Value Engineering Study for EMERGENCY DREDGING WEST FORK SAN JACINTO RIVER, TEXAS

Study Dates: 1 – 4 May 2018

PROJECT TITLE:	West Fork San Jacinto River - Emergency Dredging Greater Houston area, Texas
----------------	---

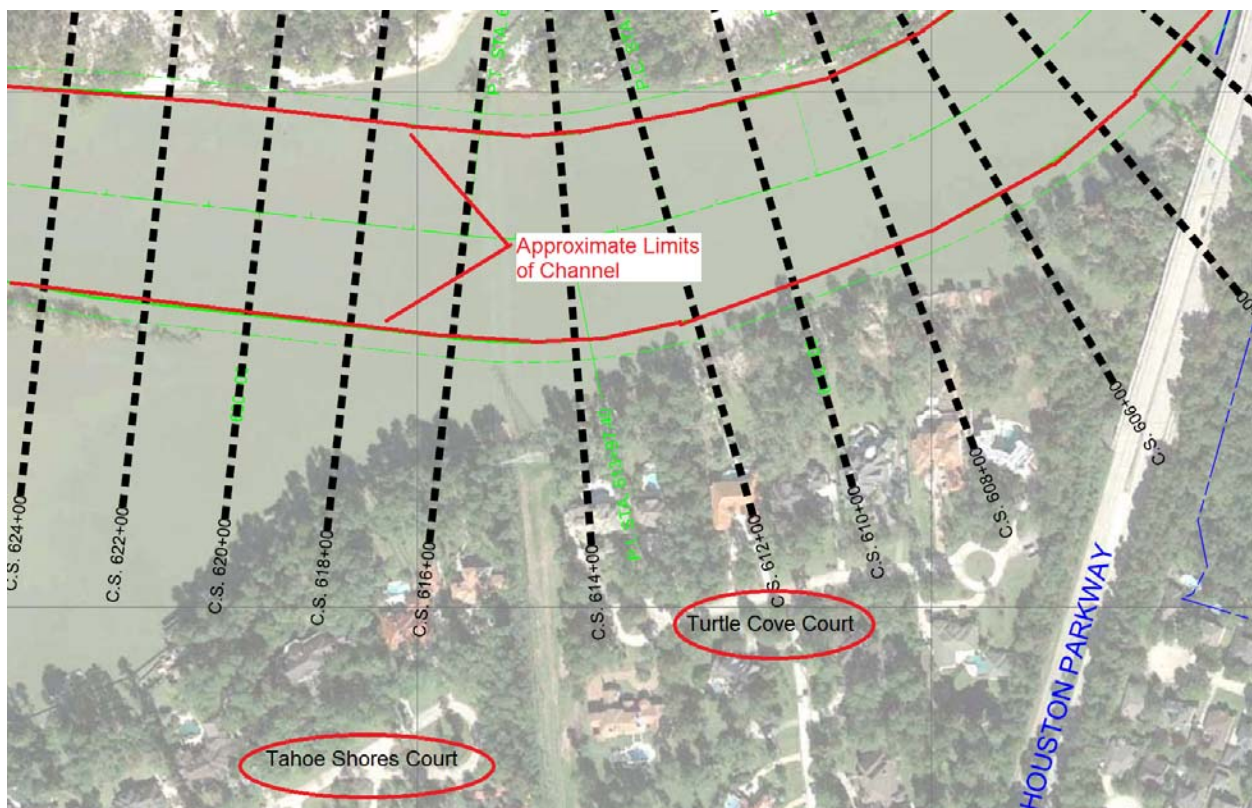
C-1. **Be proactive with local businesses and residents to head off potential complaints (Speculation List # 35, 36, 37 & 38):** It is suggested that residents and businesses which may be affected by the dredging operations be contacted for informational meetings regarding working hours and noise levels. In order to keep the contract cost-effective and achievable within the time goal, it is recommended that the contractor be allowed to work 24/7, except where the noise and lights would adversely affect nearby homes and businesses, as shown in the two reaches below:

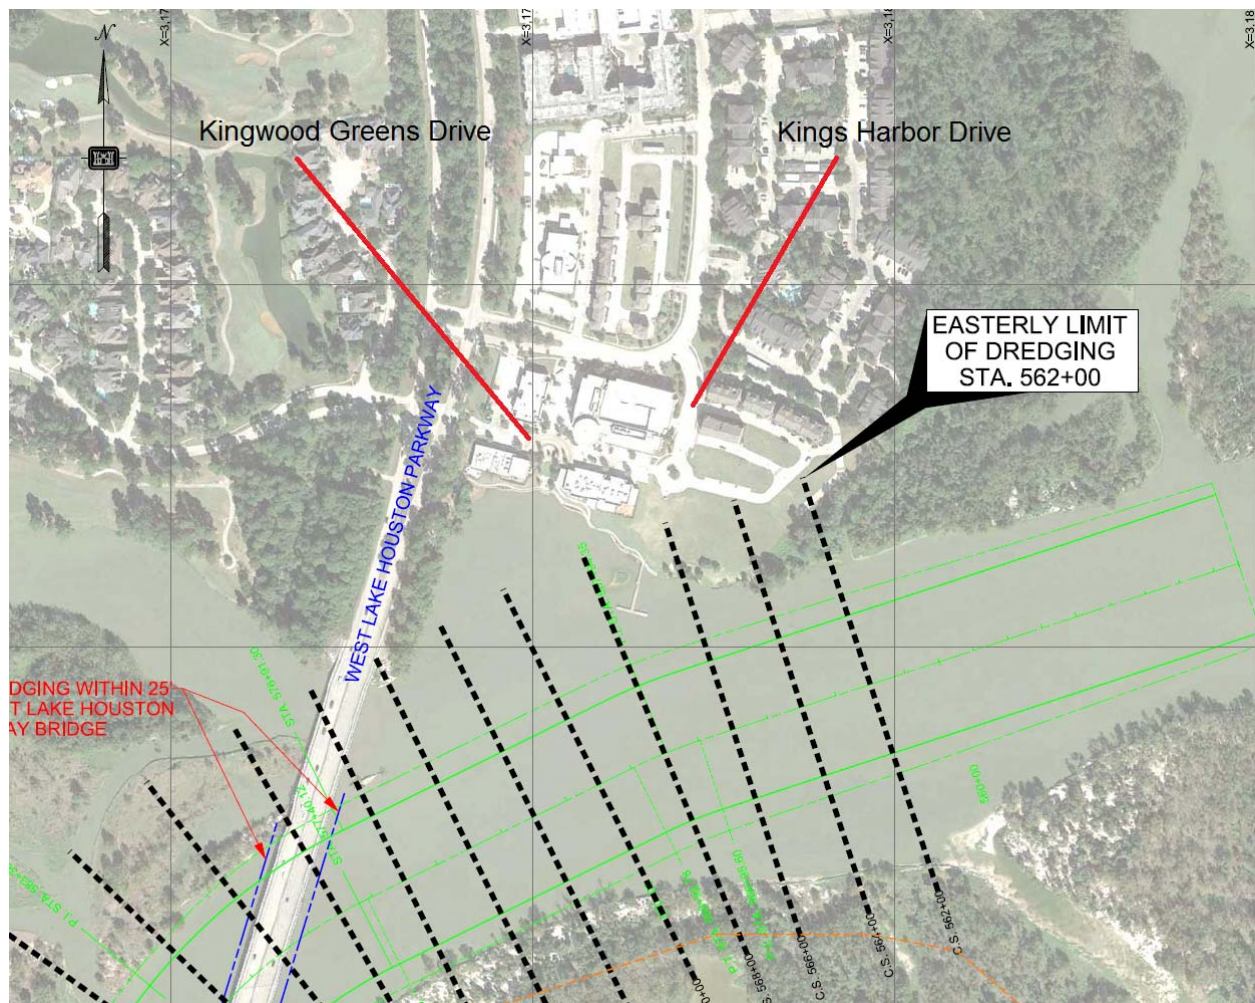
The businesses and townhomes east of West Lake Houston Parkway bridge are currently unoccupied and being restored or renovated (Kingwood Greens Drive and Kings Harbor Drive). It is suggested that construction could possibly be phased to address this reach, Section B, first for the following reasons:

- Clearing the blockage which is furthest downstream enables natural scouring from future rain events
- If the work can be completed prior to reoccupation of the businesses and townhomes would allow the contractor to work 24/7, enabling more cost-effective completion
